**Re: Hartman Publishings, 1313 Iron Ave SW, Traffic Circulation Layout  
Architect's / Engineer's Stamp NOT dated (K13-D045)**

Based upon the information provided in your submittal received 1-14-14, the above referenced plan cannot be approved for Building Permit until the following comments are addressed:

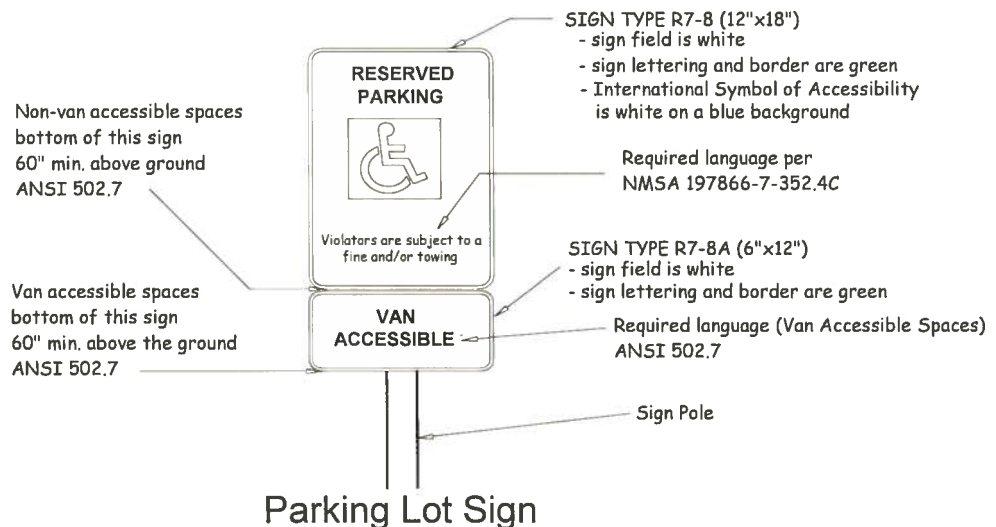
9. Is landscaping required by zoning? If so, please provide landscaping plan with next submittal. Per the *Development Process Manual*, Chapter 23, Section 7, Part B.6, curbing should be used to separate landscaping from parking areas and pedestrian ways as well as providing a physical perimeter for harvesting water. This must be clearly shown on the TCL.
10. Please add the following note: "Landscaping and signing will not interfere with clear sight requirements. Therefore, signs, walls, trees, and shrubbery between 3 and 8 feet tall (as measured from the gutter pan) will not be acceptable in this area."
11. Please refer to details below for current ADA compliant signage:

12.

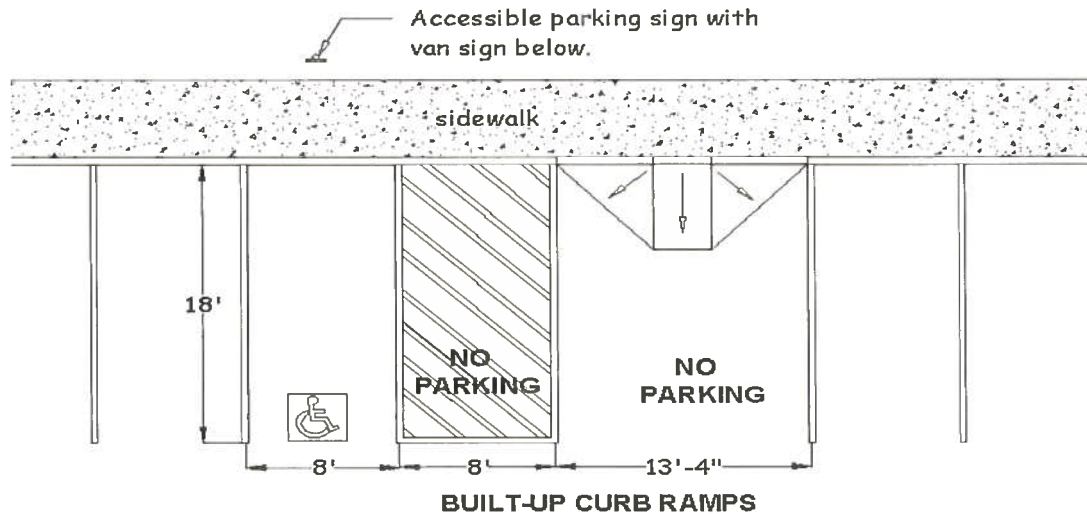
Built-up curb ramps shall not extend into the accessible parking space or access aisle.  
ANSI 502.5 and ADAAG 4.6.3 2010 Standards
